Ventura River Watershed Protection Plan Report

February 2012

Prepared for
Ventura County Watershed Protection District

Appendix A	Excerpts from Applicable Watershed Management Plans
Appendix B	Comments and Responses

Figure 2.6-6 Groundwater Basins, Upwelling and Downwelling Areas, and Fault Lines

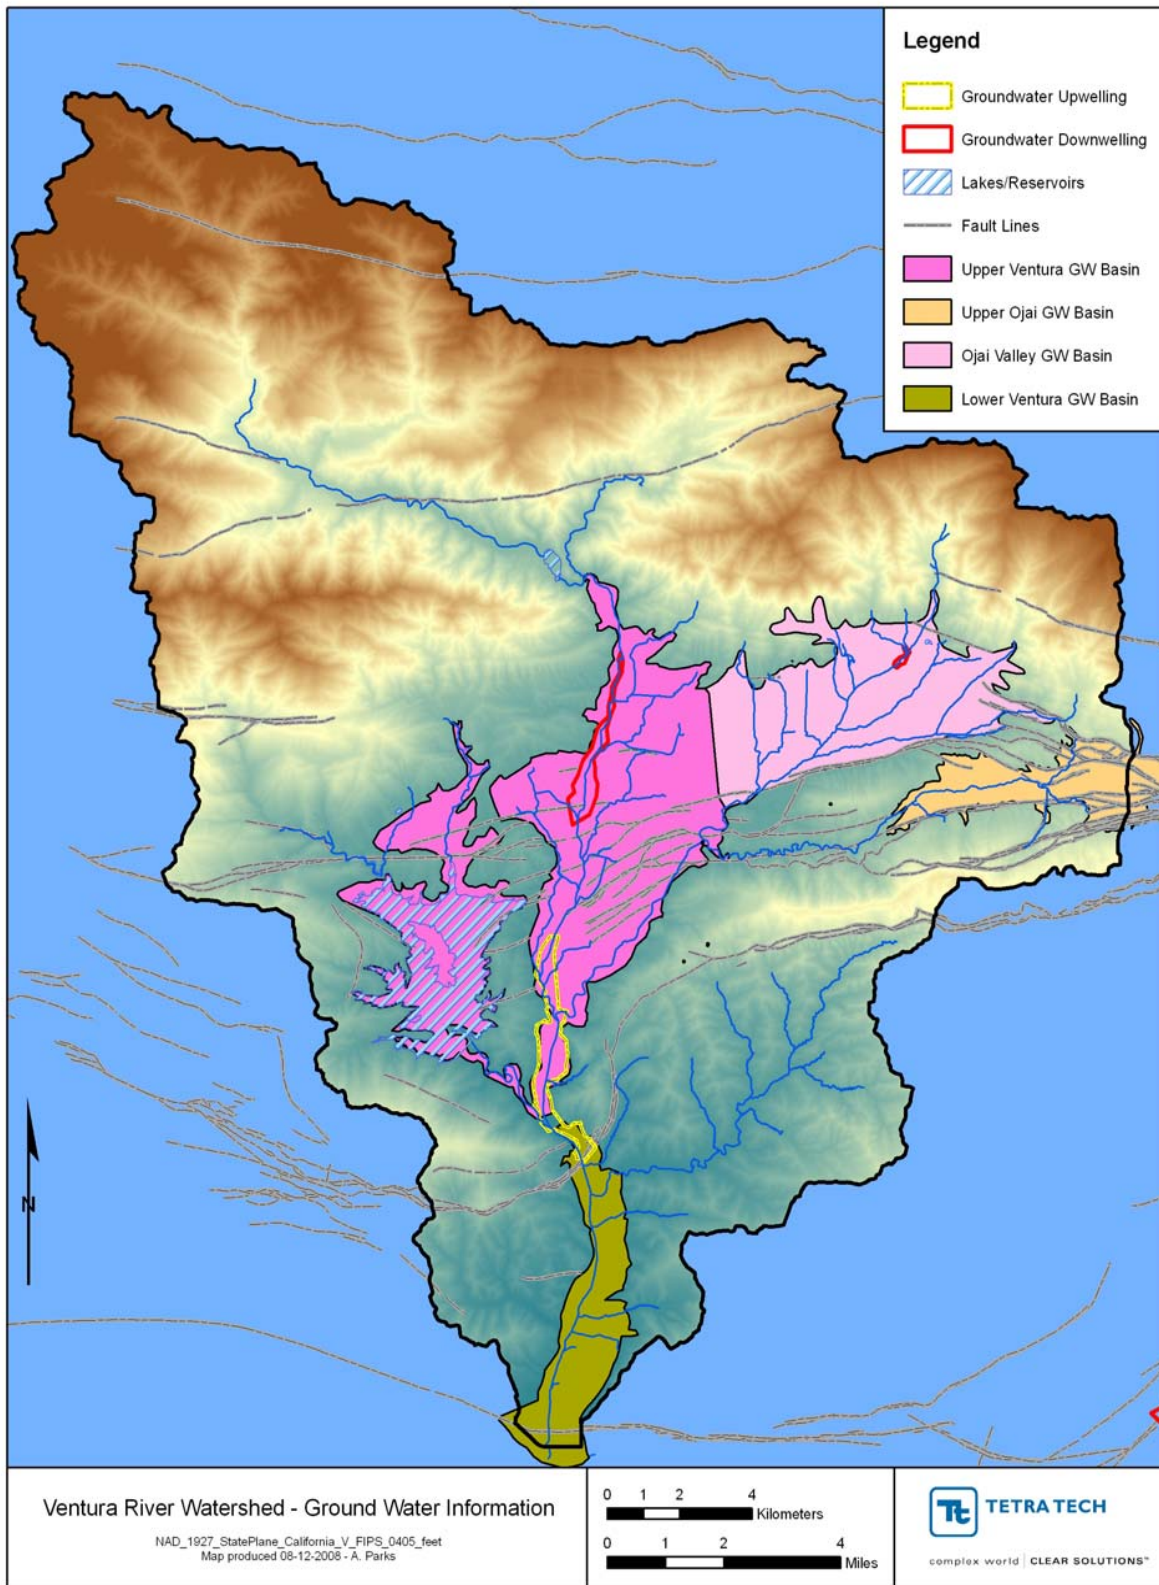
This Figure is missing
The thickness of aquifer materials is generally shallow, but varies along the river due to the geologic structure of the basin (variations in the depth to bedrock and faulting). Along the Upper Ventura River, the water-bearing units increase in thickness downstream of the confluence of Matilija and North Fork Matilija creeks, attaining a maximum thickness of approximately 200 feet on the north (down dropped) side of the Arroyo Parida-Santa Ana fault (Figures 2.6-7 and 2.6-8). Downstream of the Santa Ana fault, in the Mira Monte area, the alluvium thickness is controlled by the folded bedrock surfaces and is approximately 65 feet thick. In the Foster Park area, north of the subsurface dam and in the vicinity of the City's Nye Wells, the aquifer materials are 45 to 60 feet thick, providing a saturated thickness ranging from 35 to 45 feet (Fugro West 2002). The total storage capacity of about 14,000 AF typically empties during a 1 to 3-year critical dry period. The dominant source of recharge is direct infiltration or precipitation and percolation from local streambeds (ENTRIX and Woodward Clyde Consultants 1997).
